BROWNS FERRY NUCLEAR PLANT (BFN) - RESPONSE TO REQUEST FOR ADDITIONAL
INFORMATION - AUTOMATIC DEPRESSURIZATION SYSTEM (ADS) ACTUATION MODIFICATION
(TAC NO. 45681)

NO: E-2-P7116
REV#: 0
SH #: 2 OF 3

ECN TITLE: Automatic Depressurization System (ADS) Logic Changes

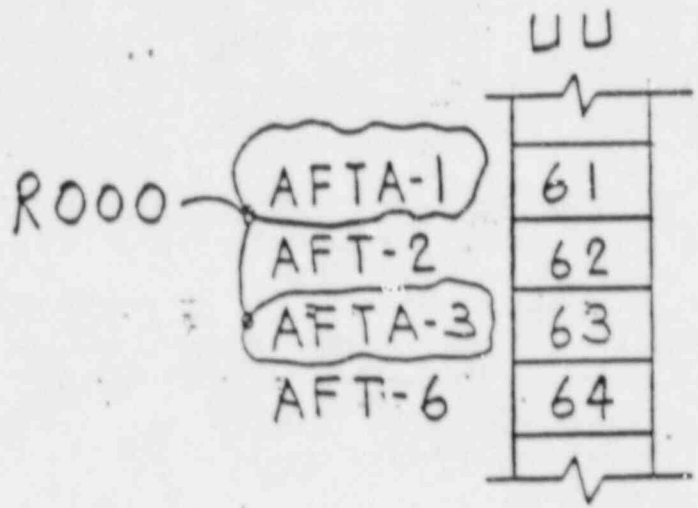
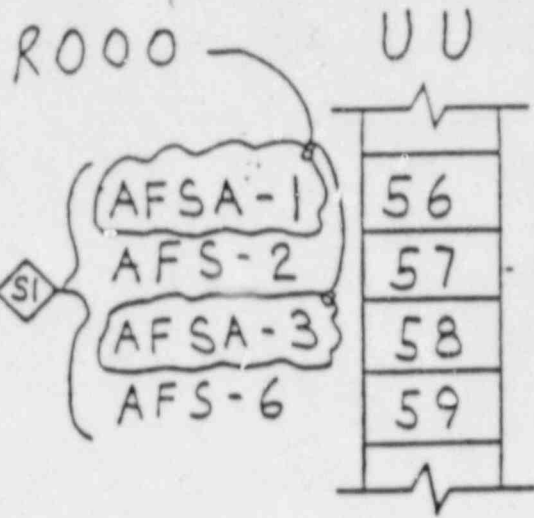
000	ECN E-2-P7116 RO REVISED WIRING	<i>Roman Kolesky</i> 5-17-88	<i>David S. Sun</i> 5/18
REV.		DRAFTED BY	CHECKED BY
THIS CHANGE IS <input checked="" type="checkbox"/> SAFETY RELATED <input type="checkbox"/> NOT RELATED TO NUCLEAR SAFETY			
BASE DRAWING	REV.	DCA NUMBER	REV.
791E489-11	919	E-2-P7116-012	OC

E-2-P7116-002

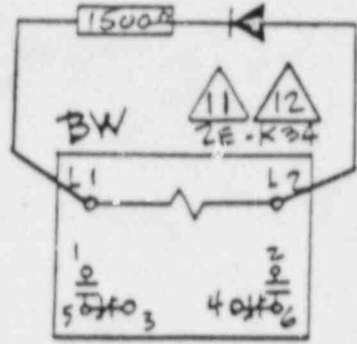
000 ECN E-2-P7116 R0 ADDED ADS LOGIC A & B
INHIBIT SWITCHES XS-1-159A & XS-1-161A.

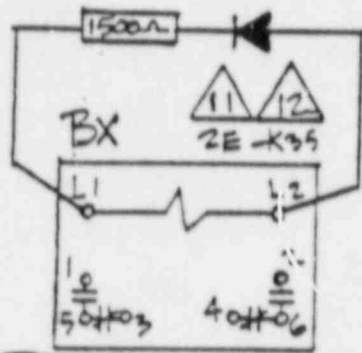
000	ECN E-2-P7116 R0 REPLACED AGASTAT TDPJ RELAYS WITH E7012SE RELAYS.	<i>Roman Kocak</i> 5-17-88	<i>David Sun</i> 5-17-88
REV.		DRAFTED BY	CHECKED BY
THIS CHANGE IS <input checked="" type="checkbox"/> SAFETY RELATED <input type="checkbox"/> NOT RELATED TO NUCLEAR SAFETY			
BASE DRAWING	REV.	DCA NUMBER	REV.
791 E 208 - 1	905	E-2-P7116- 203 ⁰²²	000

BASE DRAWING	REV.	DCA NUMBER	REV.
791E208-2	903	E-2-P7116-004	000

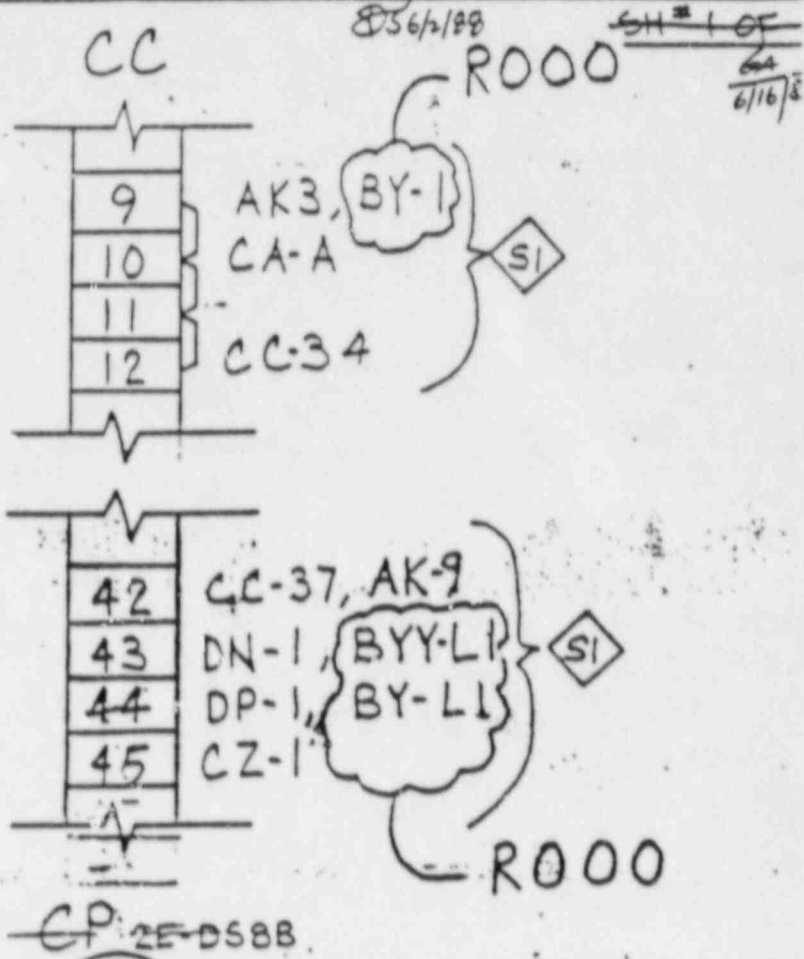
000	ECN E-2-P7116 R0 REVISED WIRING	<i>Thomas P. K. [Signature]</i> 5-17-88	<i>David L. [Signature]</i> 5-17-88
REV.		DRAFTED BY	CHECKED BY
